## 5 HILLWAY, NEDLANDS – AMENDMENT TO DEVELOPMENT APPROVAL (REDUCTION IN NUMBER OF DWELLINGS)

### Form 2 – Responsible Authority Report (Regulation 17)

<b>DAP Name:</b>	Metro Inner-North JDAP	
<b>Local Government Area:</b>	City of Nedlands	
<b>Proposed Amendments:</b>	Modification to approved plans to reduce the number of dwellings from 10 as approved to 9.	
<b>Applicant:</b>	Element Advisory Pty Ltd	
<b>Owner:</b>	Hillway 20 Pty Ltd and Hillway 80 Pty Ltd	
<b>Value of Amendment:</b>	N/A	
<b>Responsible Authority:</b>	City of Nedlands	
<b>Authorising Officer:</b>	Peter Mickleson, Director Planning and Development	
<b>LG Reference:</b>	DA20/55430	
<b>DAP File No:</b>	DAP/20/01741	
<b>Date of Original DAP decision:</b>	29 September 2020	
<b>Application Received Date:</b>	13 October 2020	
<b>Application Statutory Process Timeframe:</b>	60 Days	
<b>Attachment(s):</b>	<ol style="list-style-type: none"> <li>1. Amended Plans date stamped 28 October 2020</li> <li>2. Applicant Letter and overview dated 9 October 2020</li> <li>3. Previous Determination Notice and approved plans.</li> <li>4. Letter from Lavan Legal dated 8 October 2020</li> </ol>

1 Level 2  
A\_105 SCALE: 1:100

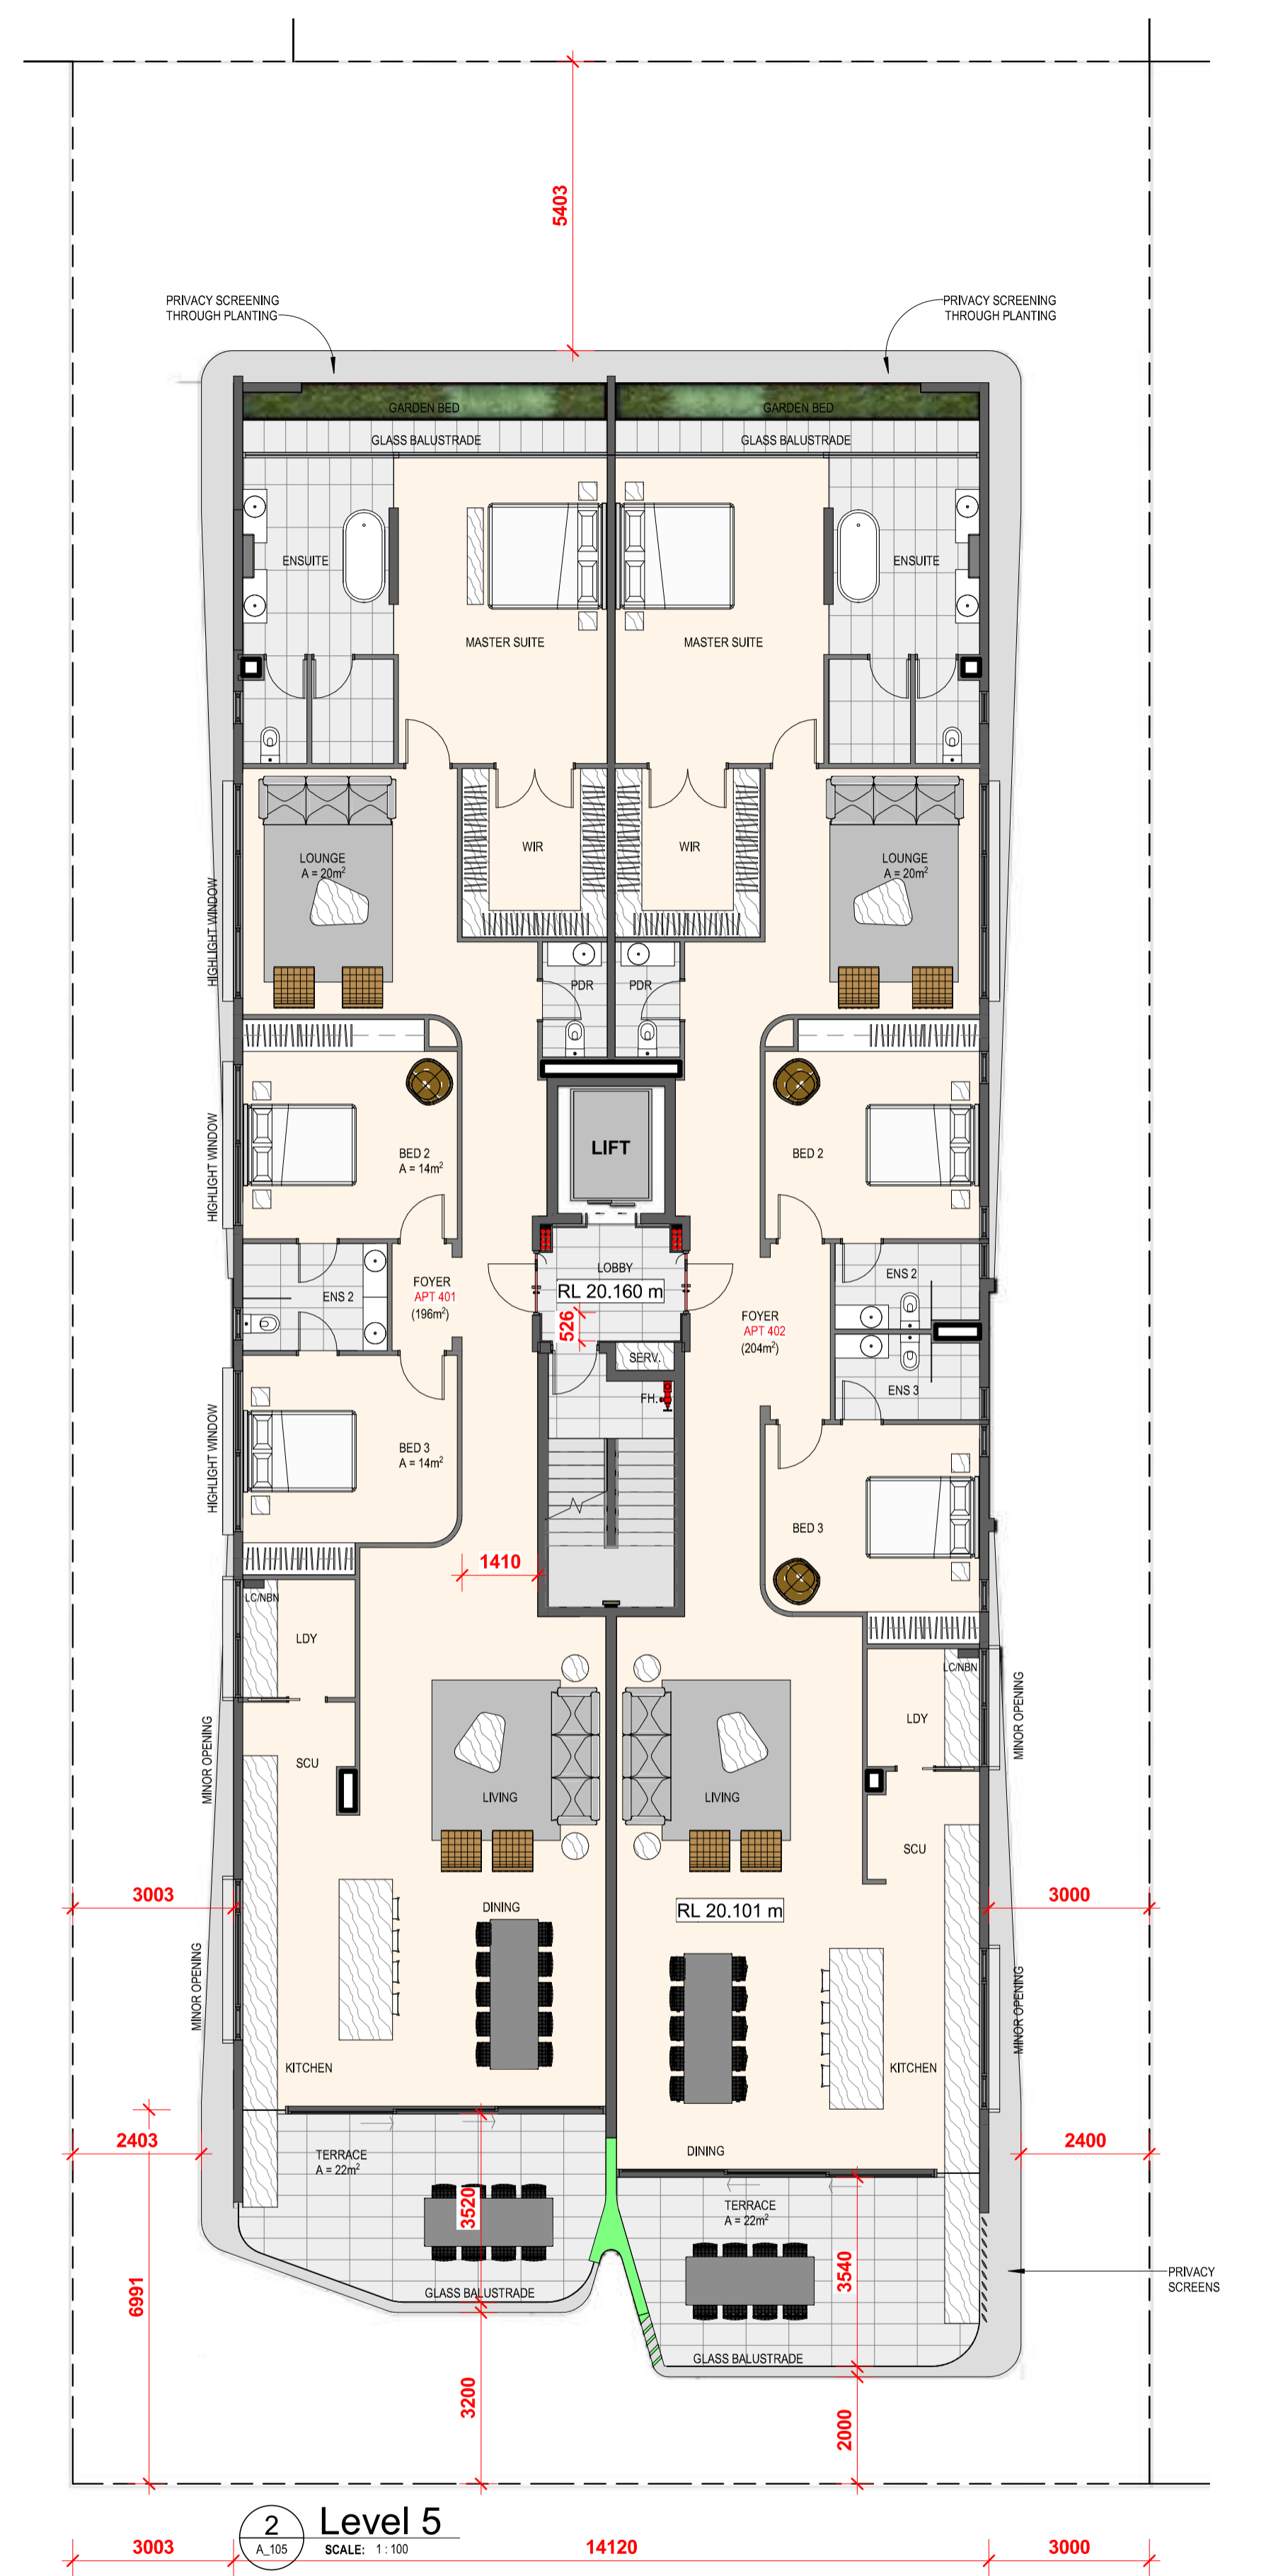
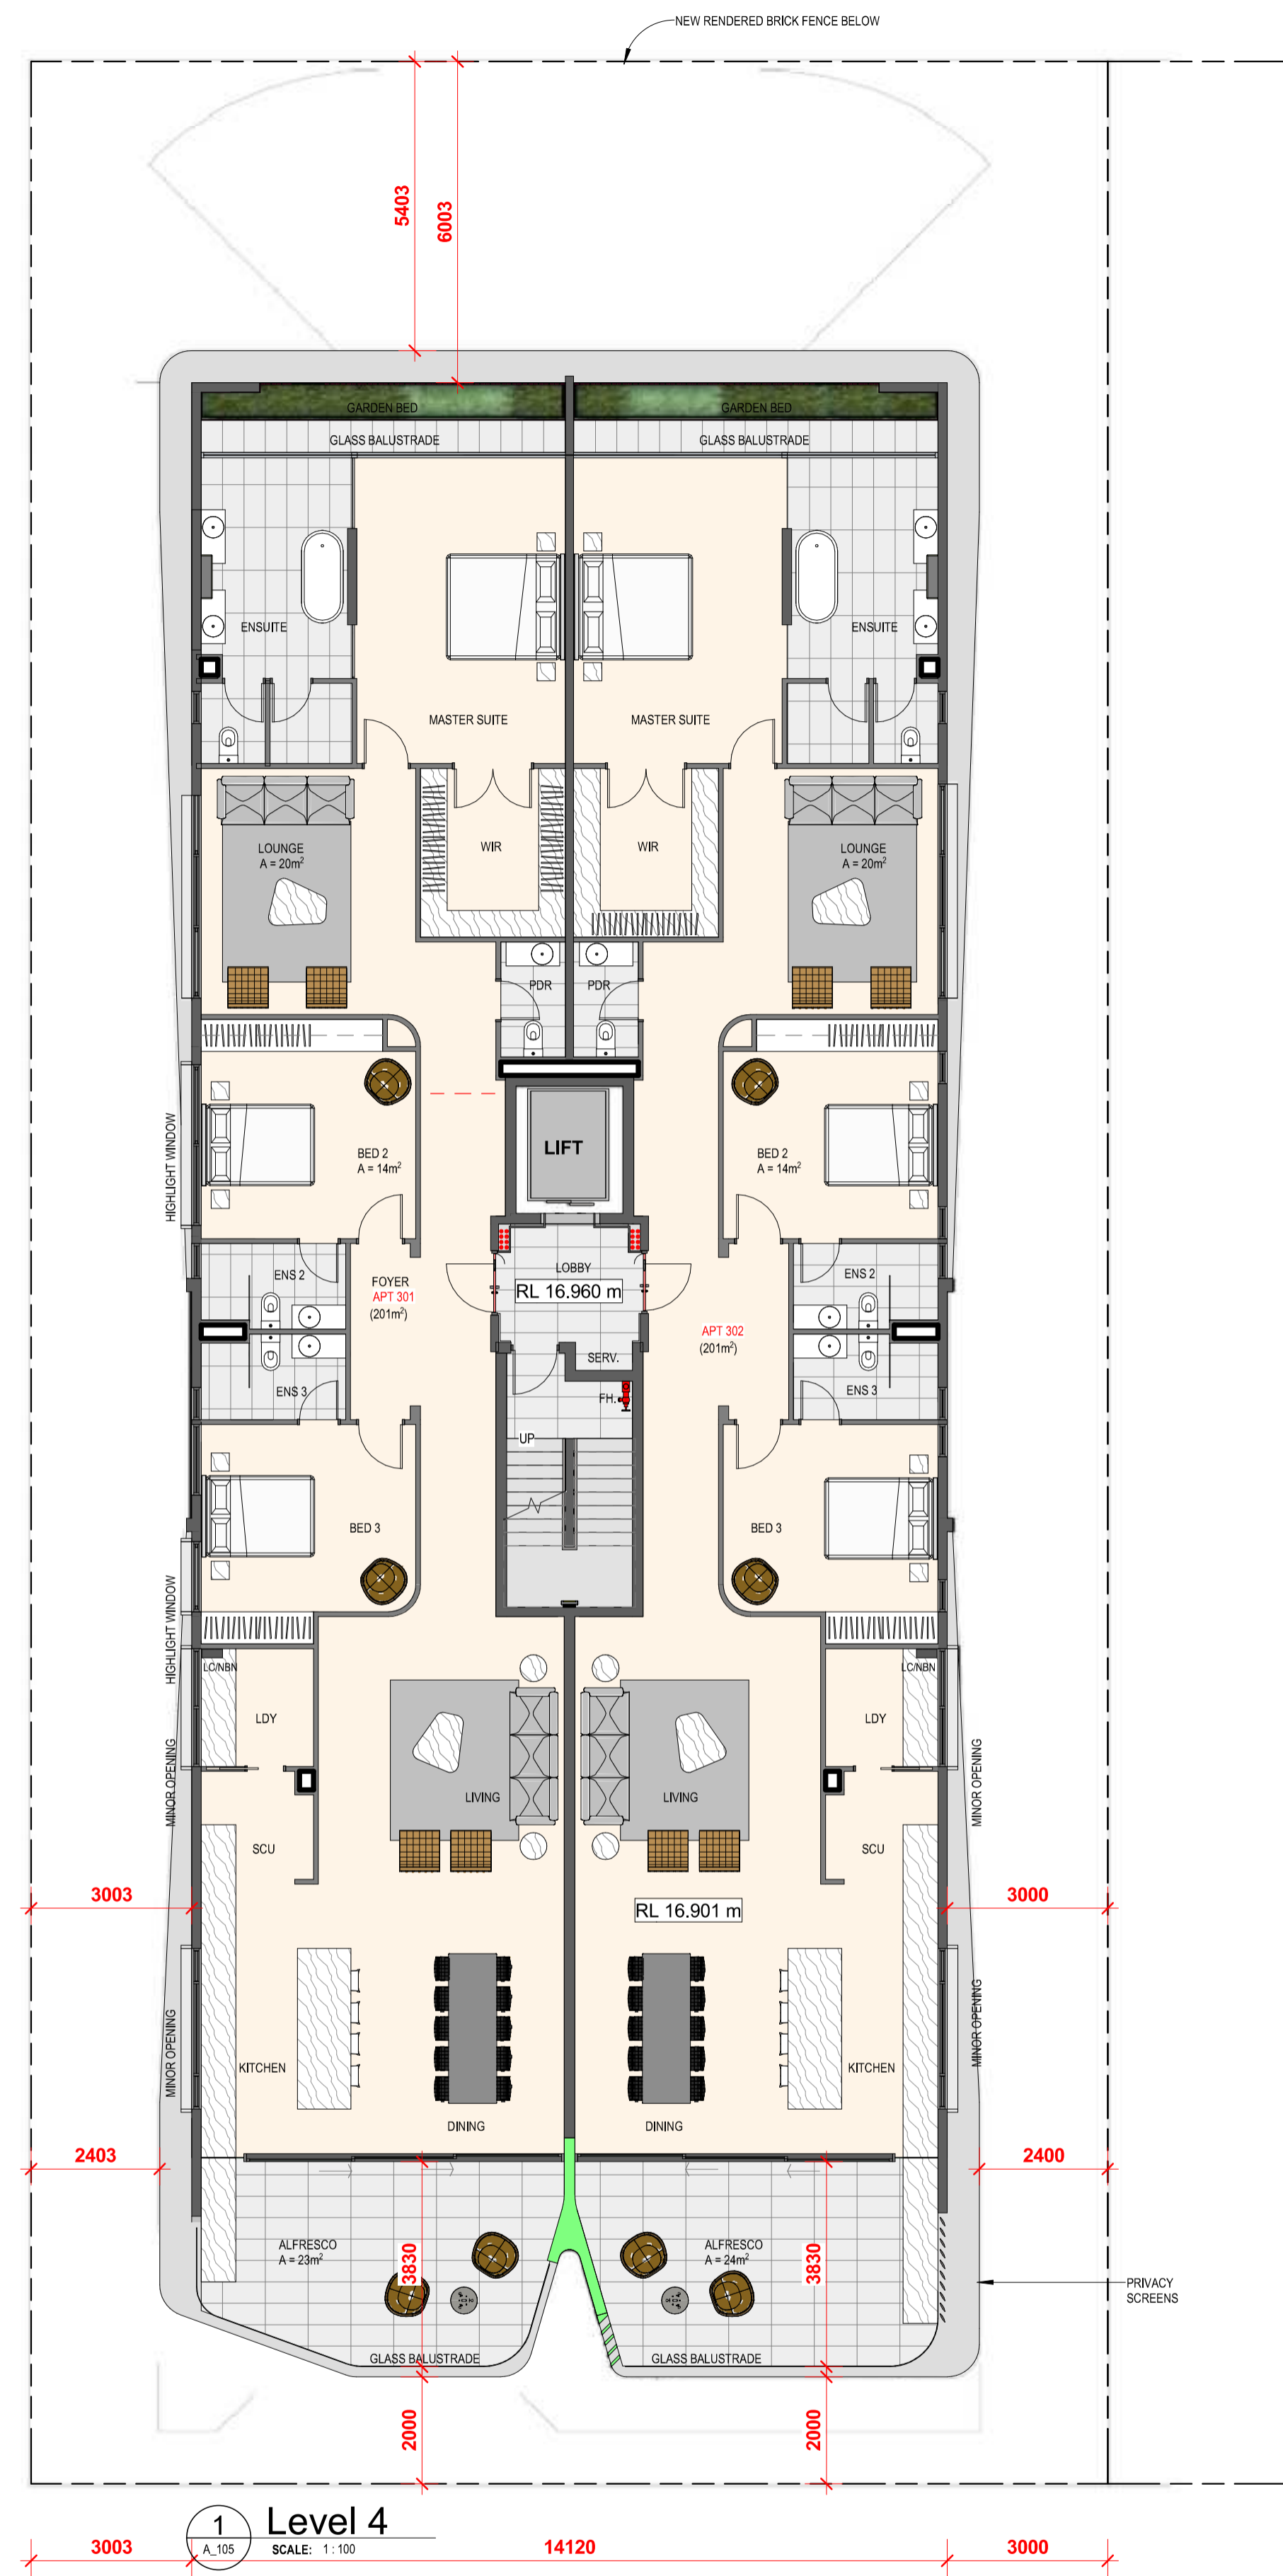
It is proposed to reduce the number of dwellings in the multiple dwelling complex from 10 as approved on 29 September 2020 to 9. This will be achieved by deletion of Apartment 303 on Level 4. The floor area previously occupied by this dwelling will be taken up by expanding Apartments 301 and 302. The new layout of Apartments 301 and 302 will be similar to that on approved Apartments 401 and 402 located on Level 5. A revised set of plans and applicant overview are included at **Attachments 1 and 2** respectively.

- Rear (northwest) elevation – Balcony removed, living/dining windows replaced by windows to Master Bedroom and ensuite and planter boxes and screening provided.
- Side (northeast and southwest) elevations – window changes to suit revised internal layout.

required from the Living / Dining windows to the rear balcony. The outdoor living area has been removed and the rooms reconfigured to provide for bedrooms on the rear elevation. The acceptable outcome visual privacy setback has subsequently reduced from 6m to 3m. However, the building remains setback to the rear boundary at 6.0m from the outer edge of the planter box and 7.3m from the windows. The proposed narrow balcony is 0.6m wide to allow access for maintenance of the planter boxes and window cleaning. It is not considered outdoor living space and is not subject to visual privacy requirements.

The reconfiguration of the internal layout has introduced a lounge area on the side elevations. The approved plans included windows to bedrooms on the side elevations. The acceptable outcome visual privacy setback of 3.0m was met by the development. The acceptable outcome for a lounge room is 4.5m to boundaries. However, the current amendments propose highlight windows to the lounges on both side elevations, removing the need for a visual privacy requirement.

Whilst not required to meet the element objectives, the amendments introduce a planter and screen along the rear elevation to augment the visual privacy setback. This approach was previously approved for Levels 5 and 6.

1. Amend Condition 24 to read as follows:

*Vegetation screening located on the rear balconies of Units 301, 302, 401, 402 and 501 is to be planted and maintained at all times to a minimum height of 1.6 metres above the finished floor level of the balcony to ensure compliance with Element 3.5 of the Residential Design Codes.*
